**Date** 29/06/2021  
**To** Terry Lu (Tony Owen Partners)  
**From** Nathan Banks (Arcadis)  
**Copy to** Kate Carroll (Arcadis)  
**Subject** Biodiversity Advice – 164 & 170 Croatia Ave, Edmondson Park

Arcadis have been engaged by Tony Owen Partners to make an assessment of the proposed development at 164 & 170 Croatia Avenue to determine whether the requirements of the *Biodiversity Conservation Act 2016* should be considered.

Figure 1. Proposed development with encroachment into non-certified lands identified

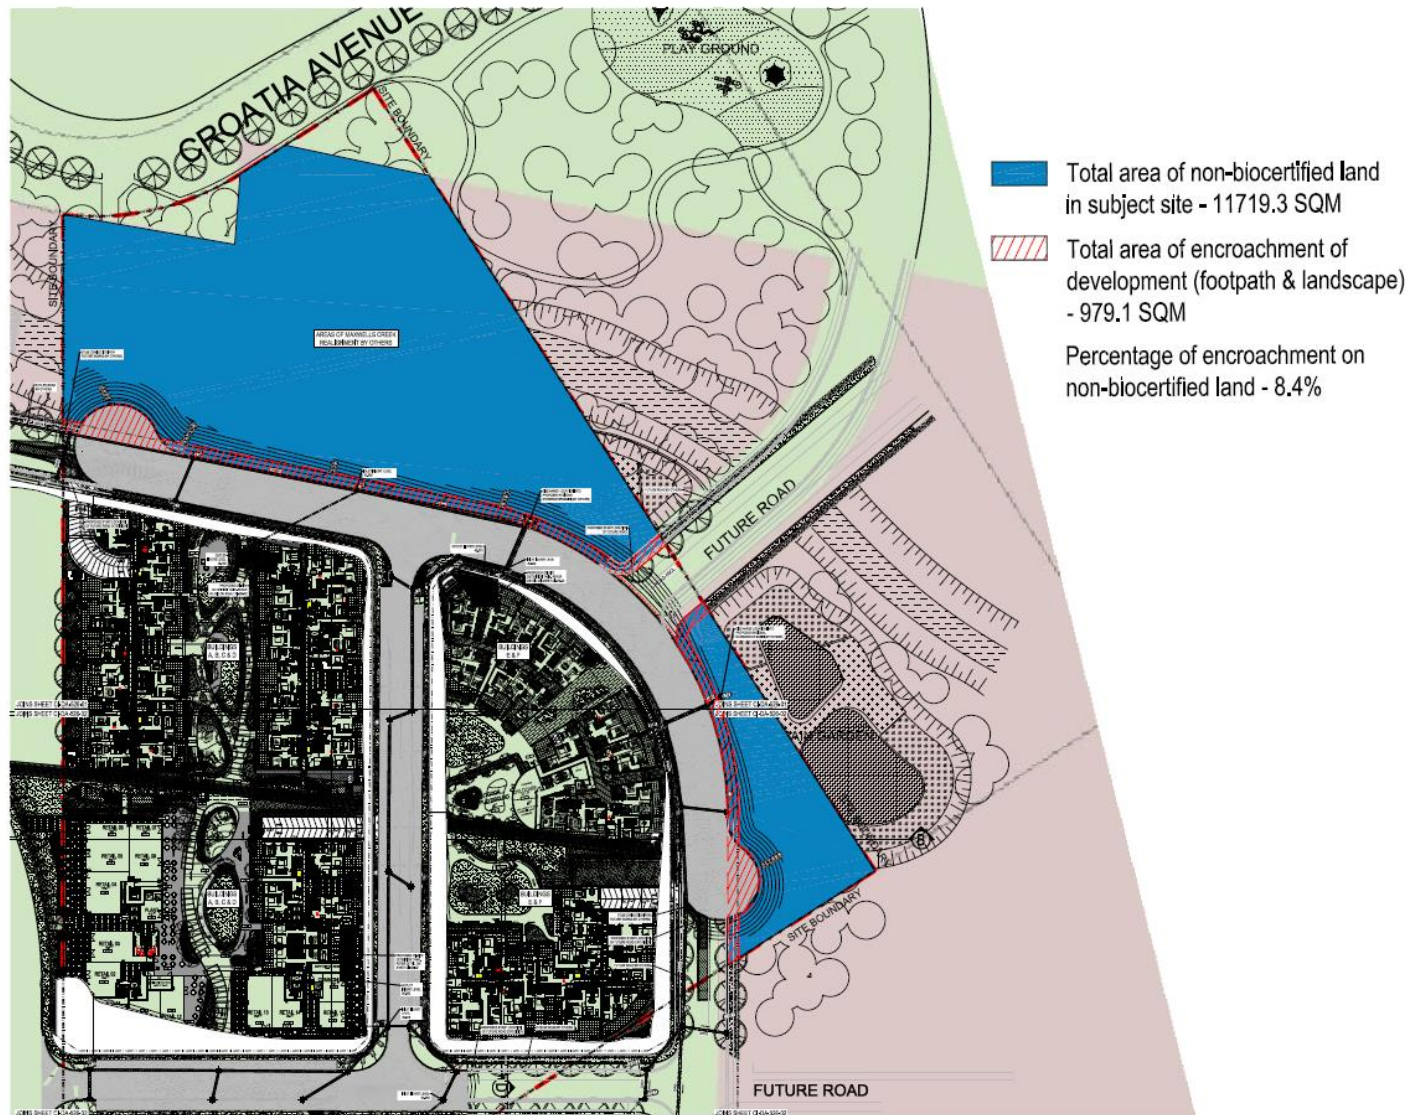
*The SEE assumes that the entire site is biocertified (as noted on page 66), and therefore consideration of ecological matters was not required. However, Geocortex indicates that the RE1 zoned portion of the site is not biocertified.*

*The SEE notes that the pedestrian path and tree planting within the Bernera Road reserve would extend into the RE1 zoned land, which is not biocertified. Further, it appears that the temporary turning heads (and associated batters) on the perimeter road may potentially impact upon land that is not biocertified.*

*It is therefore recommended that the extent of impacts in relation to the extent of biocertified land is clarified.*

*If impacts extend into land that is not biocertified, further information should be submitted to demonstrate whether the Biodiversity Offsets Scheme has been triggered. The evidence should include, but is not limited to:*

The design for Stage 1 of the Proposal is situated entirely within areas subject to biodiversity certification under the order (2007) and subsequently does not require assessment against the *Biodiversity Conservation Act 2016* or Biodiversity Offset Scheme (BOS).

The current design for Stage 2 of the Proposal would trigger the Biodiversity Offset Scheme (BOS) due to the design intersecting an area mapped on the Biodiversity Values Map (DPIE 2021) nearest the north-eastern edge (see yellow hashed area in Figure 3).

An encroachment of 979.1 square metres into non-biodiversity certified lands does not trigger the clearing area threshold of 0.25 hectares for a minimum lot size of 300 square metres, as such Stage 2 of the Proposal does not trigger the BOS under this element.
